ORIGINATION FORM

Proposed Revisions to a Standard Plans Index

Index Number: 700-040
Sheet Number (s): All of 5
Index Title: Cantilever Sign Structure

SHEET
1 of 5

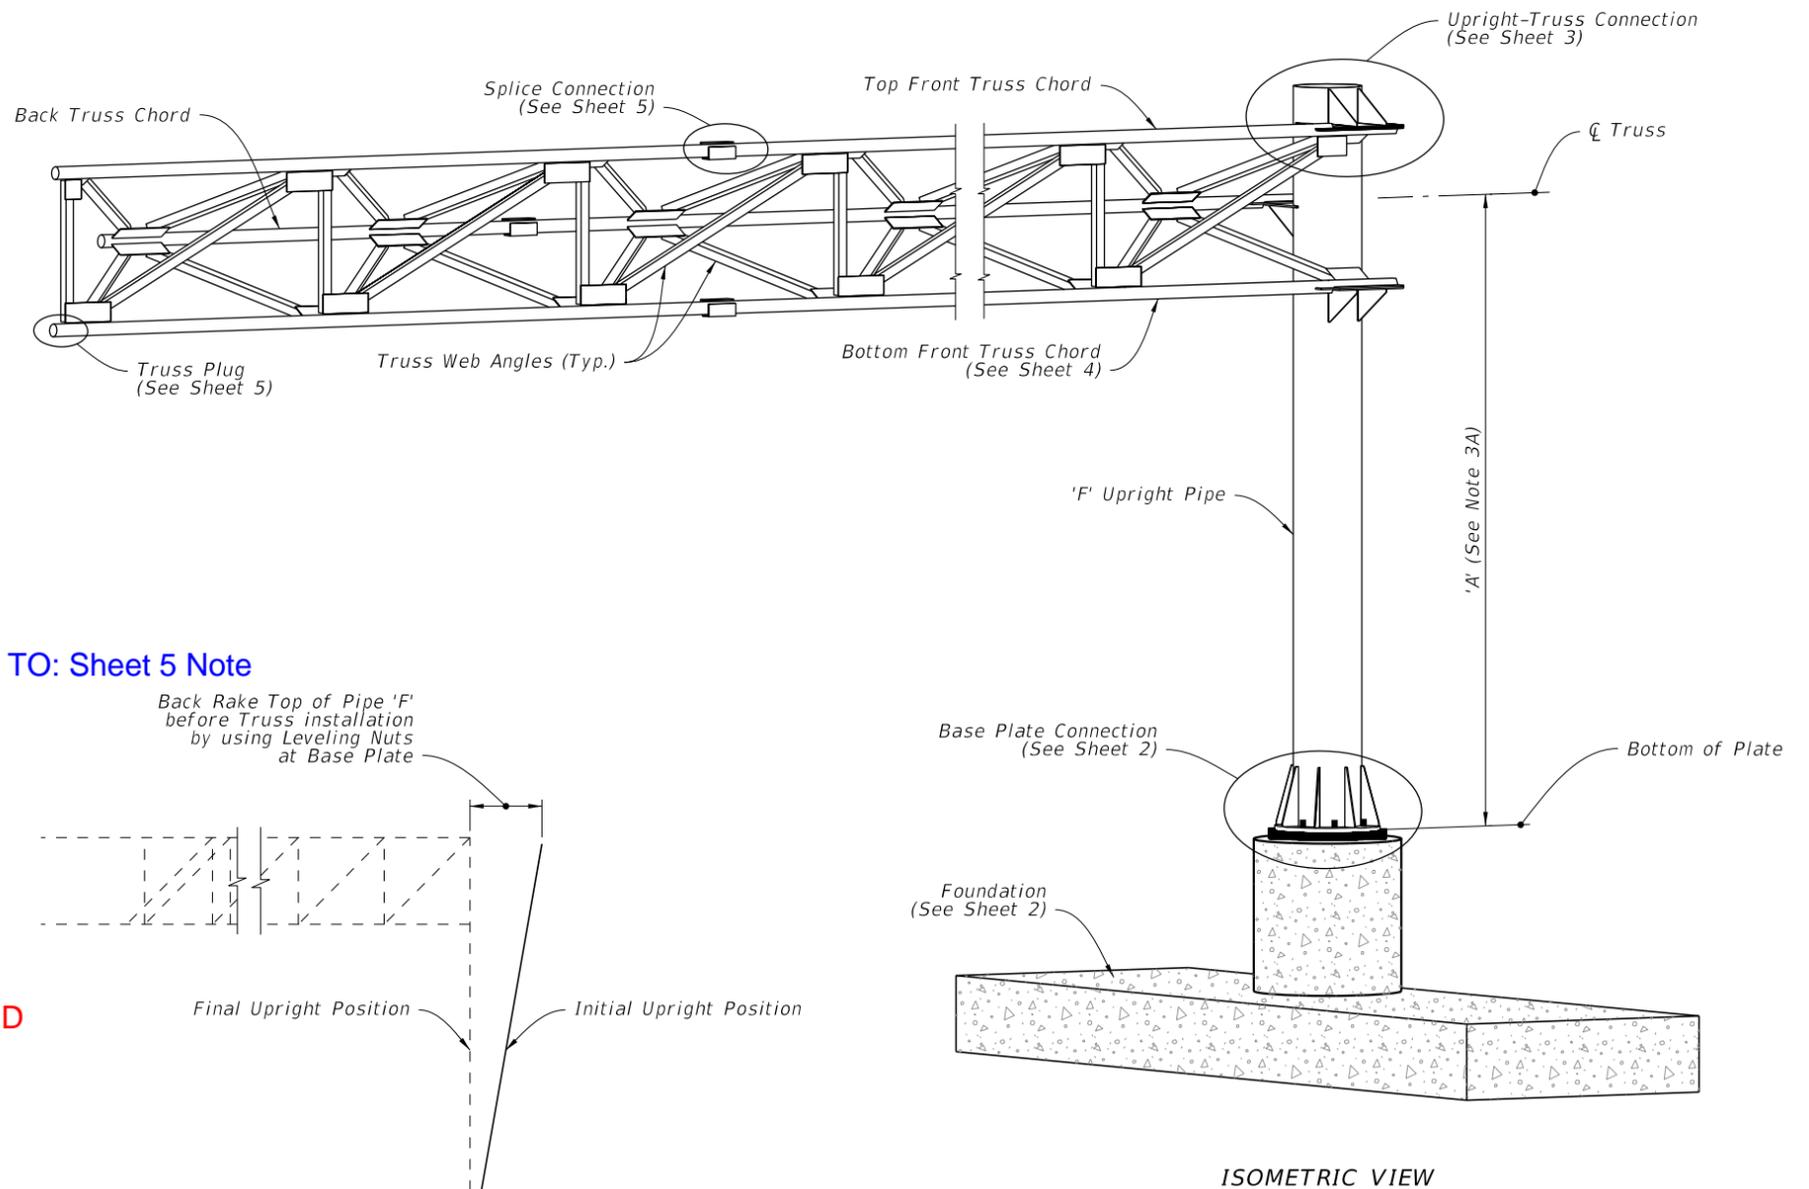
- Sheet 1: Updated Notes to General Notes; Added New General Note 1 - "Meet the requirements of Specification 700."; Deleted Notes 4 through 7; Moved Note 5.B to Sheet 5 Notes; Renumbered Notes.

~~4. Materials:~~

~~5. Fabrication:~~

~~7. Construction:~~

GENERAL COMMENT: Some material, construction, and fabrication information was deleted. Information is either already covered in Standard Specifications OR will be added to Section 700, 962 or 965 in conjunction with these revisions.

ADDED NEW NOTE 1: Meet the requirements of Specification 700.

MOVED TO: Sheet 5 Note

SECTION A-A

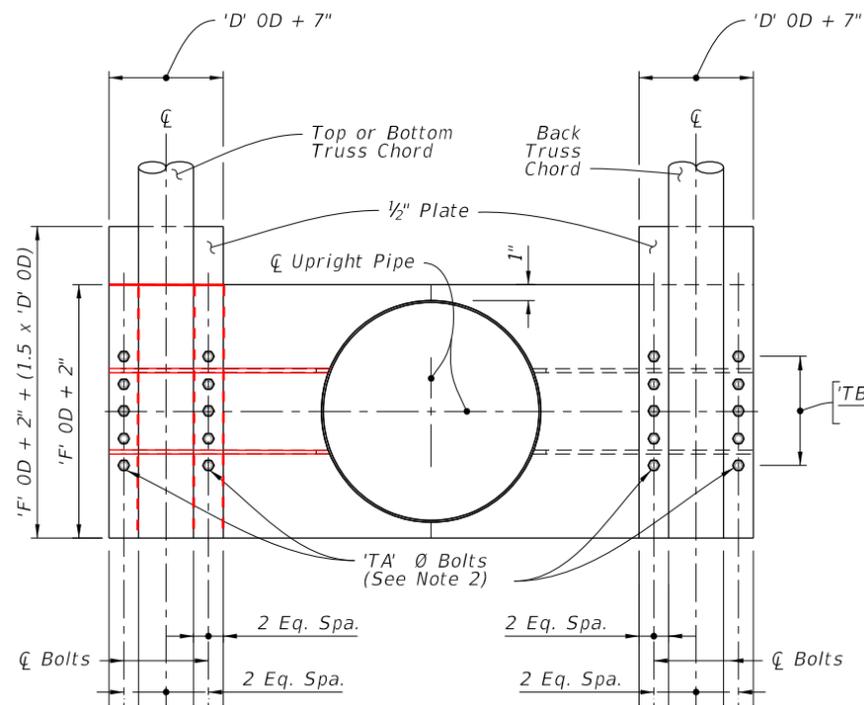
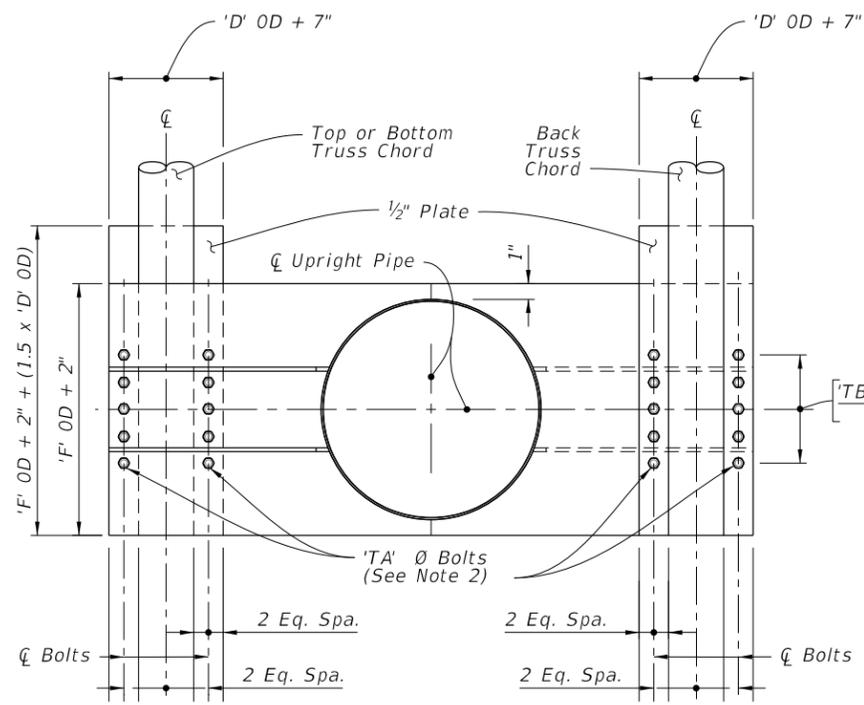
- Sheet 3: Updated line work on Section A-A to correctly reflect correct geometry; Added (See Sheet 1) to the 'TH' and the 'TF' welds.
- Sheet 4: Corrected reference in Detail F.

Sheet 3: Updated for errors and clarity

SPLICE CONNECTION DETAIL

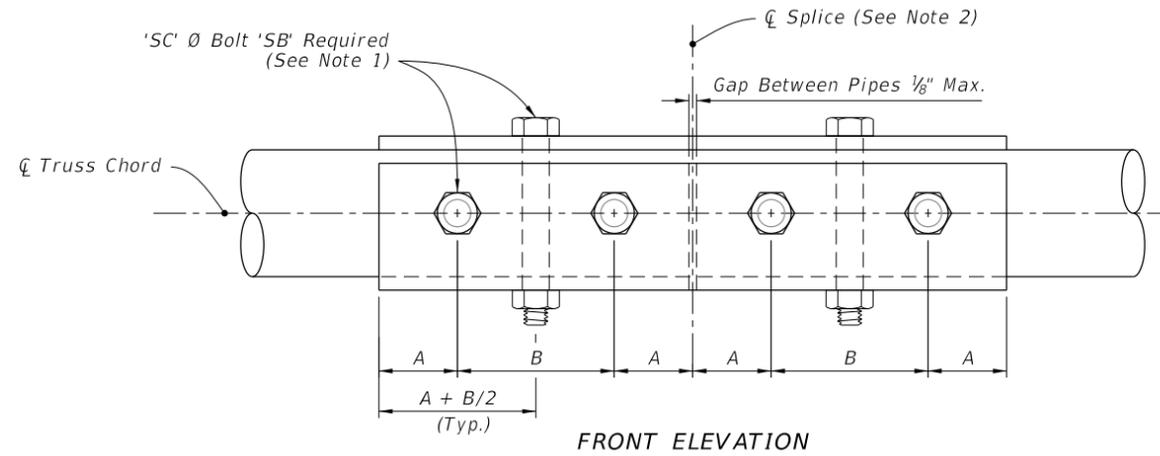
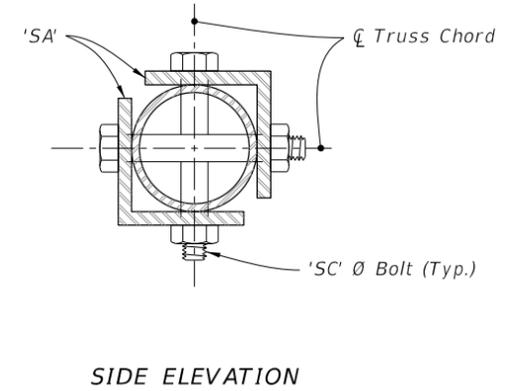
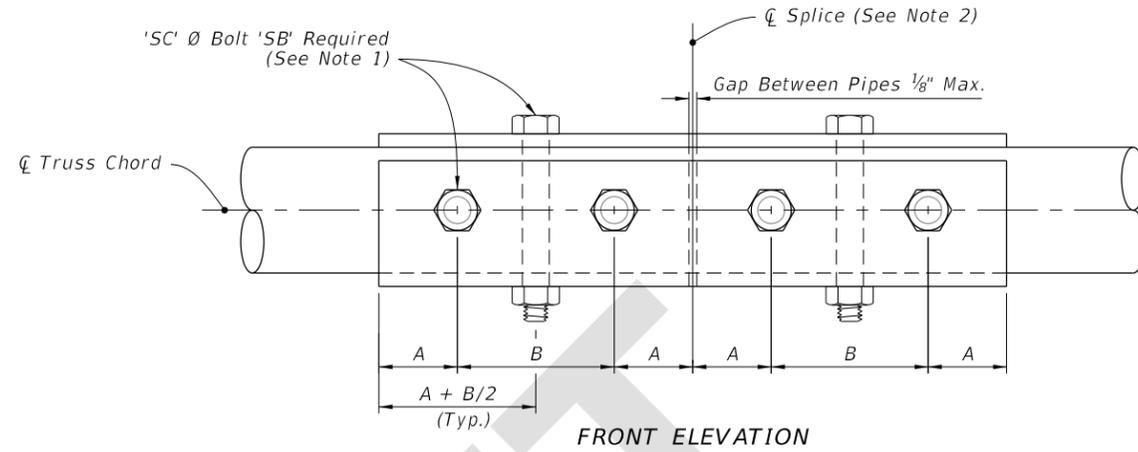
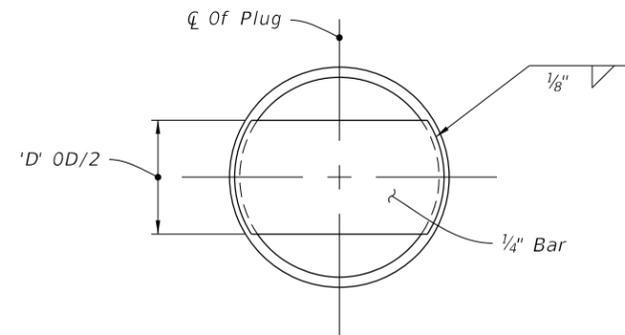
- Sheet 5: Added General Note 5.B as New Note 3 - "Chord Splices: "SD" Panel from upright is the closest panel in which chord splice may be used. See Plans for CANTILEVER SIGN STRUCTURE DATA TABLE. Minimum splice spacing is two truss panel lengths apart."

ADDED NOTE 3:
 Chord Splices: "SD" Panel from upright is the closest panel in which chord splice may be used. See Plans for CANTILEVER SIGN STRUCTURE DATA TABLE. Minimum splice spacing is two truss panel lengths apart

1. Only 6 bolts are shown in detail for clarity. (One Half Each Side Of Splice)
2. Splices are not permitted for trusses less than or equal to 40', Splice optional for trusses greater than 40'.
3. Chord Splices: "SD" Panel from upright is the closest panel in which a chord splice may be used. See Plans for CANTILEVER SIGN STRUCTURE DATA TABLE. Minimum splice spacing is two truss panel lengths apart.

LAST REVISION 11/01/22	DESCRIPTION:		FY 2023-24 STANDARD PLANS	CANTILEVER SIGN STRUCTURE	INDEX 700-040	SHEET 2 of 5

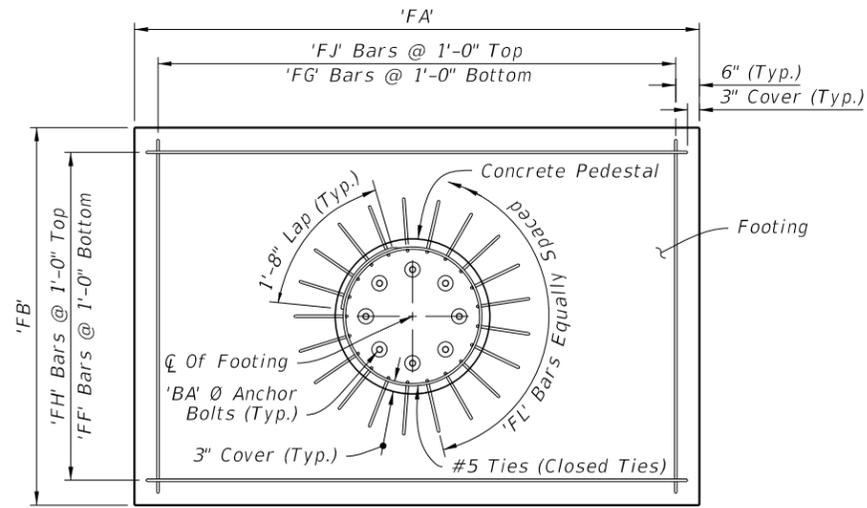
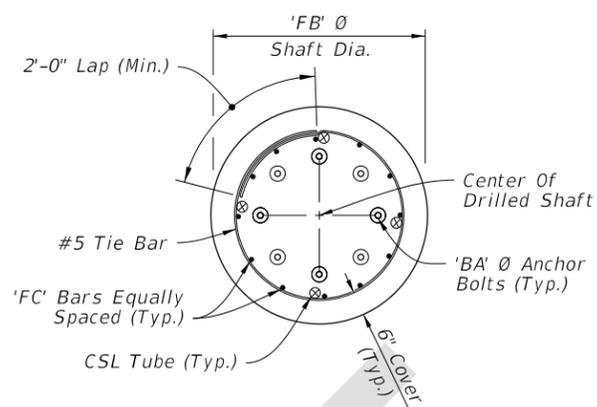
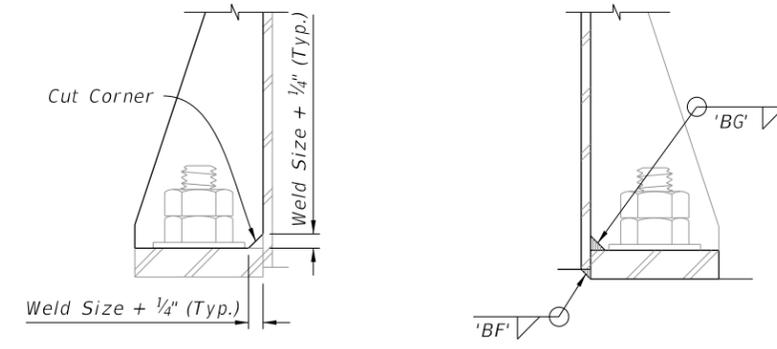
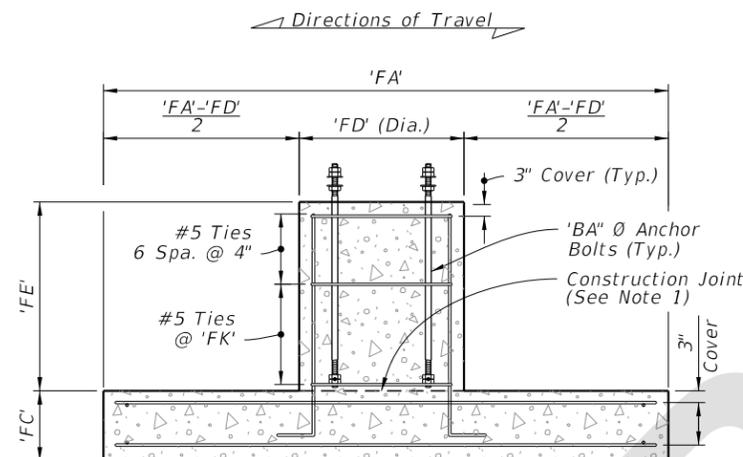
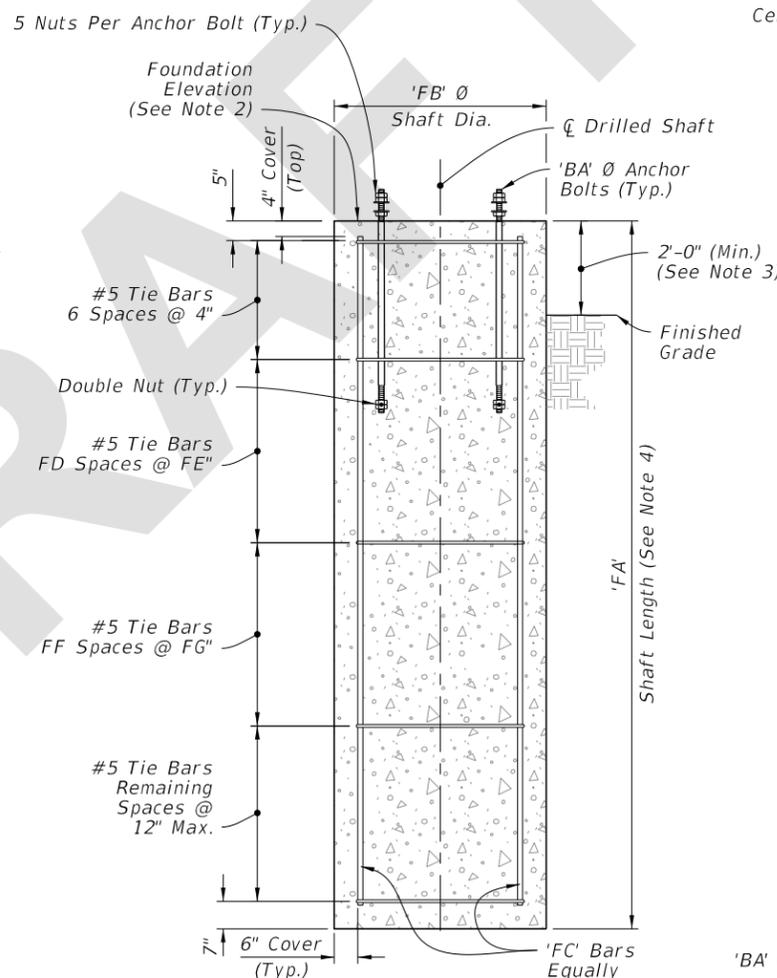
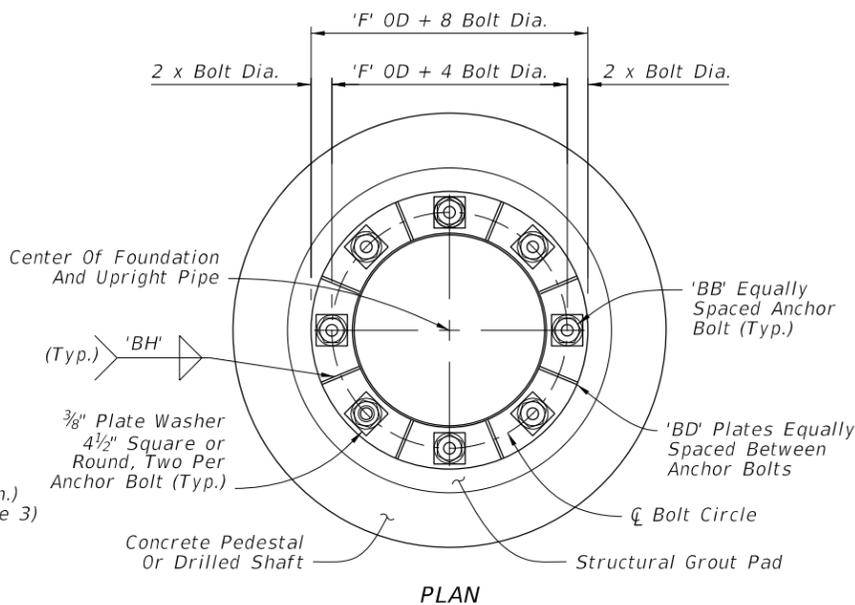
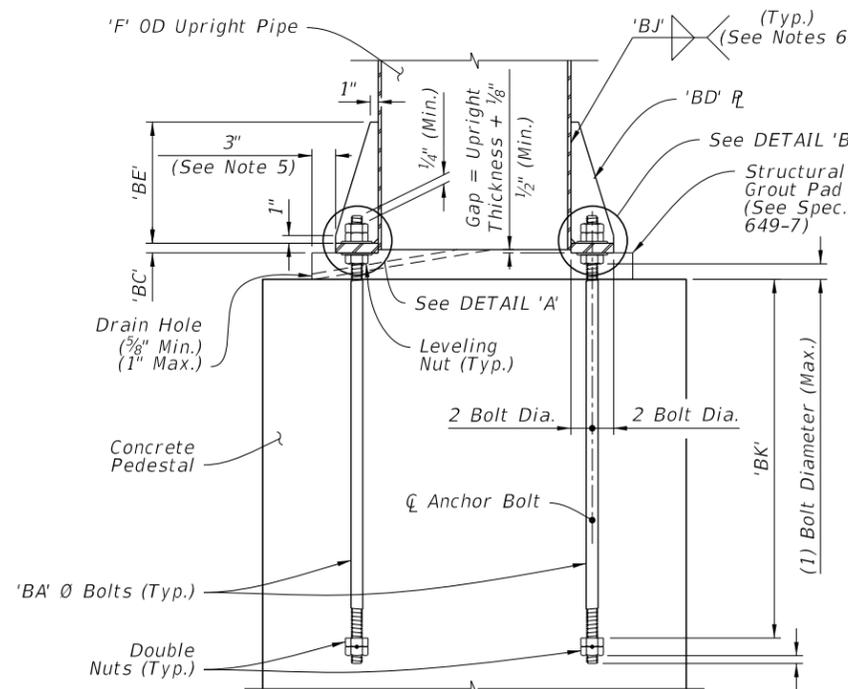
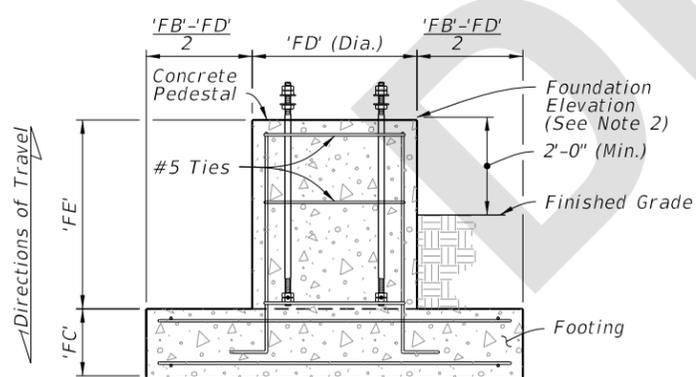
- Sheet 2: Deleted Note 7 ; Added Plate Washers to the Anchor Bolts and new callout "5 Nuts Per Anchor Bolt (Typ.)"; in the FOUNDATION details; Updated the Plate Washer callout and the weld references in the BASE PLATE CONNECTION details; Added new note detailing the weld pattern of the 'BD' plates indicating that they should be welded in a star pattern; Changed dimension 'BK' extents in Base Plate Connection detail to match calculations.

Sheet 2: New Note - This process is to help prevent residual stress buildup in base plate connection to prevent cracking.

6. Wrap fillet weld around the stiffener termination on the tube wall.
7. Weld plates 'BD' in a star pattern. A star pattern is one in which the plates on opposite and near opposite sides of the pole circle are successively welded in a pattern resembling a star. For an 8 plate circle with plates sequentially numbered 1 to 8, weld the plates in the following order: (1, 5, 7, 3, 8, 4, 6, 2).
